The Commission has issued the enclosed Amendment No. 23 to Facility License No. DPR-33 for the Browns Ferry Nuclear Plant, Unit No. 1. This amendment consists of changes to the Technical Specifications in response to your request dated May 28, 1976 as supplemented June 1, 1976.

BROWN FERRY NUCLEAR PLANT UNIT NO. 1

Amendment No. 23
License No. DPR-53

AMENDMENT NO. 23 TO DPR-33

Figure 6.3-1

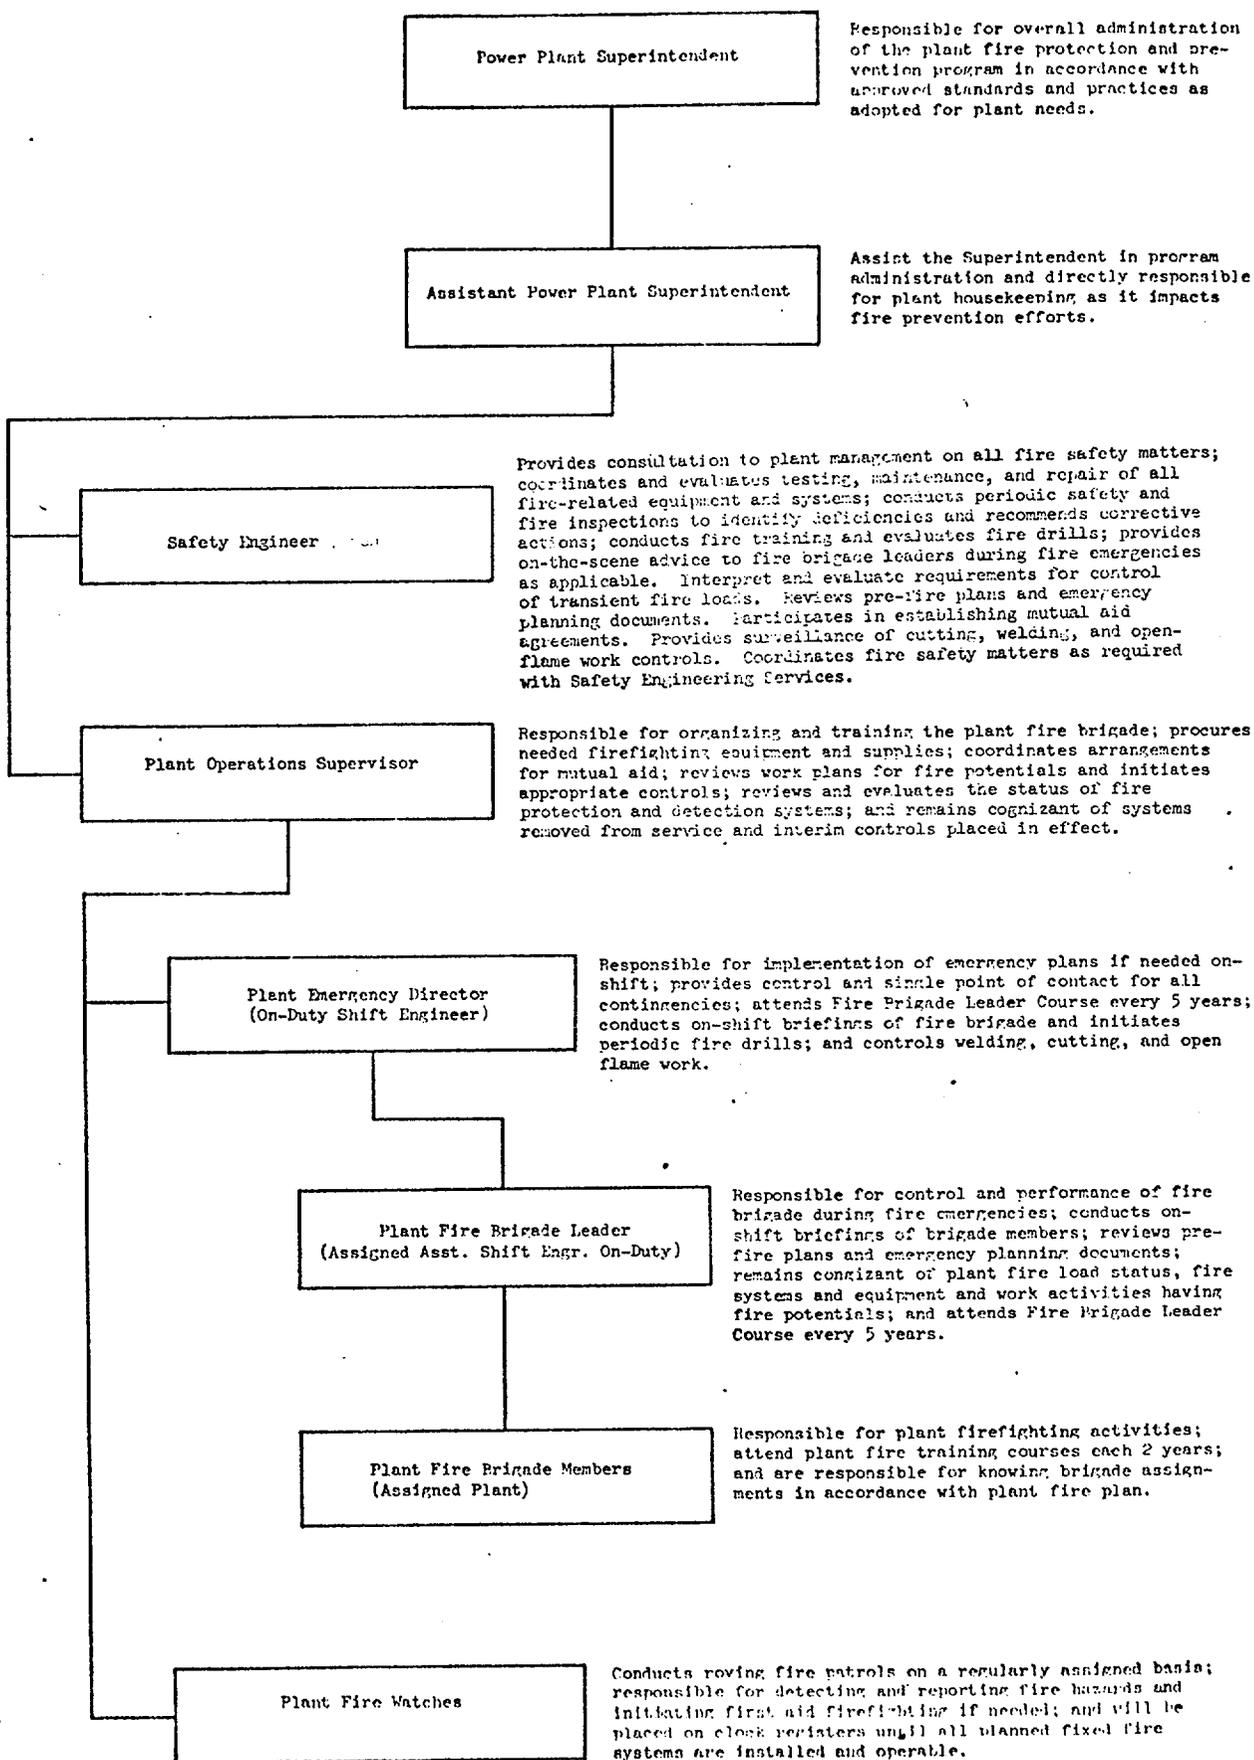
1. An independent fire protection and loss prevention inspection and audit shall be performed annually utilizing either qualified TVA personnel or an outside fire protection firm.
 2. An inspection and audit by an outside qualified fire consultant will be performed at intervals no greater than 3 years. (The first inspection and audit will be during the period of June - September 1977.
- F. If it becomes necessary to breach a fire stop, an attendant shall be posted on each side of the open penetration until work is completed and the penetration is resealed.
- G. The minimum in-plant fire protection organization and duties shall be as depicted in Figure 6.3-1.

Figure 6.3-1 describes the in-plant fire protection organization including the roving fire watch. In addition, other operating personnel periodically inspect the plant during their normal operating activities for fire hazards and other abnormal conditions.
